NTD-NRC-94-4110
DCP/NRC0044
Docket No.: STN-52-003

SUBJECT: WESTINGHOUSE RESPONSES TO NRC REQUESTS FOR ADDITIONAL
INFORMATION ON THE AP600

NTD-NRC-94-4110
ATTACHMENT A
AP600 RAI RESPONSES
SUBMITTED APRIL 28, 1994

Figure 230.47-1 Factor of Safety To Resist Overturning

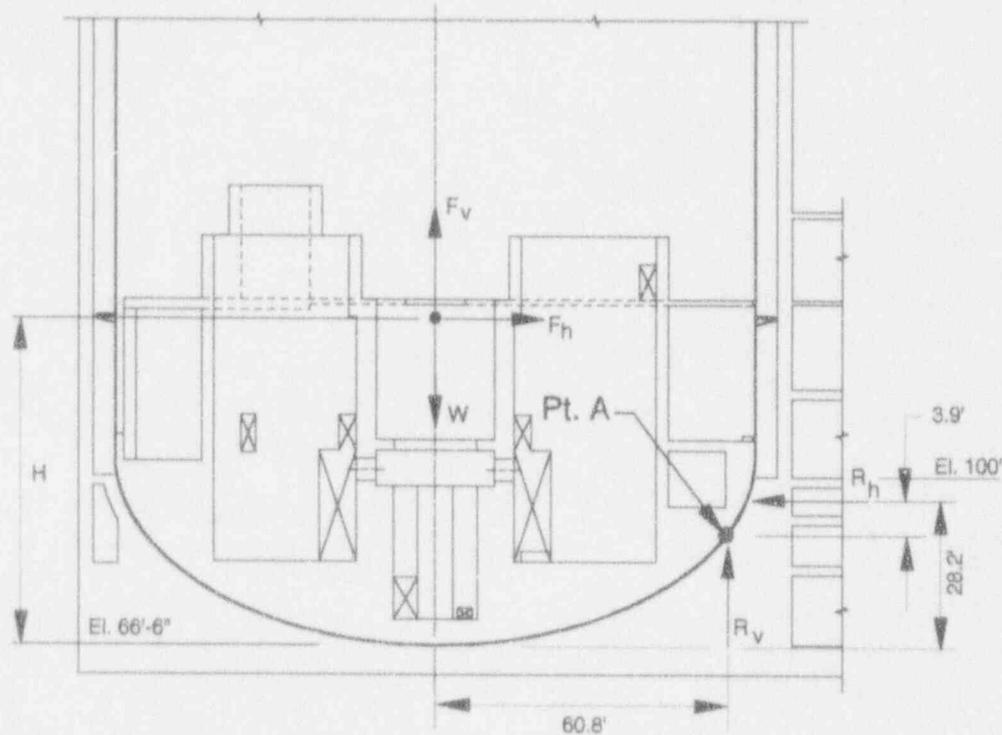
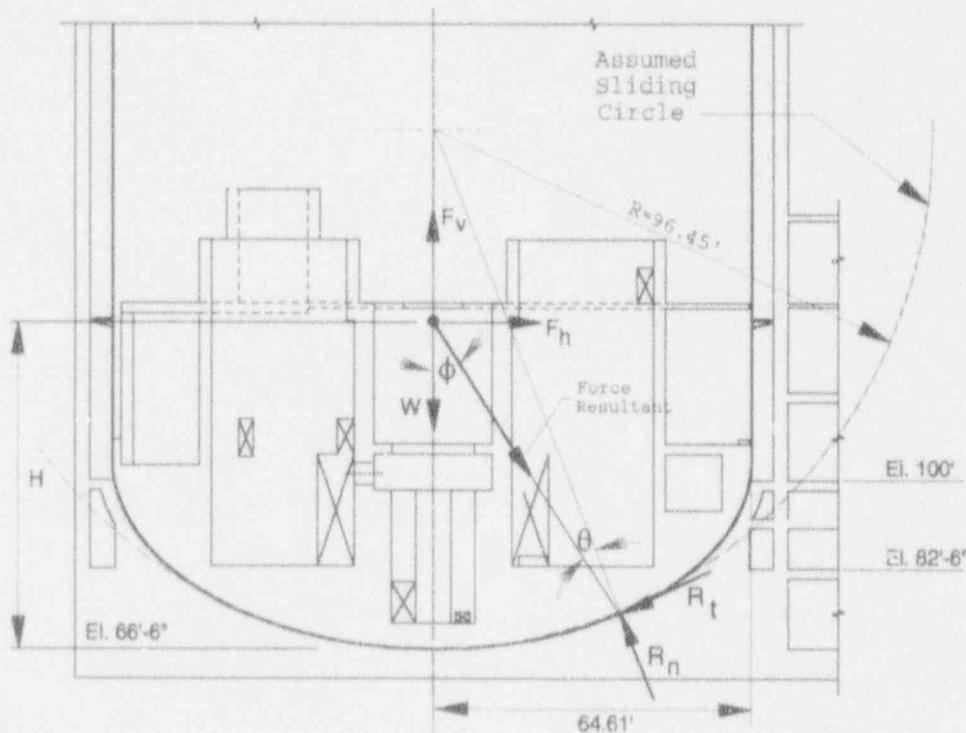
Section 3.8.2.1.2 of the SSAR states that the vertical and lateral loads on the containment vessel and internal structures are transferred to the basemat below the vessel by friction and bearing. This statement implies that there are no shear studs or anchors between the internal structures, steel containment vessel and reinforced concrete basemat. Provide an analysis to demonstrate the dynamic stability of the containment vessel during an SSE event or a seismic margins earthquake.

There are no shear studs or anchors between the internal structures, steel containment vessel and reinforced concrete basemat. The dynamic stability of the containment vessel was evaluated for a SSE event using a conservative friction coefficient of 0.4 at the concrete/steel interface. The factors of safety computed are equal to 2.5 and 3.0 against overturning and sliding, respectively.

The evaluation is graphically presented in Figures 230.47-1 and 230.47-2 using the following input data:

The dynamic stability analysis for the safe shutdown earthquake shows a large safety factor of 2.5 against overturning. Based on an analysis similar to that shown in Figure 230.47-1, incipient overturning would be predicted at a ground input level of 0.79g for an earthquake having a similar response spectrum shape as the safe shutdown earthquake. This would not represent failure since small lift-off would not prevent safe shutdown. Dynamic stability is therefore assured for the seismic margins review level earthquake.

$$H = \frac{M}{F_h} = \frac{1,506,770}{23,045} = 65.4 \text{ ft}$$

Assumed Overturning about Point "A", the low point of the minimum bearing area required to support the dead weight + SSE loads at the concrete cradle.

$$\text{Overturning Moment} = F_h \times 41.1 + F_v \times 60.8 = 1,498,606 \text{ K-ft}$$

$$\text{Resisting Moment} = W \times 60.8 + R_h \times 3.9 = 3,812,417 \text{ K-ft}$$

$$\text{Factor of Safety} = \frac{\text{Resisting Moment}}{\text{Overturning Moment}} = 2.5 \geq 1.1$$
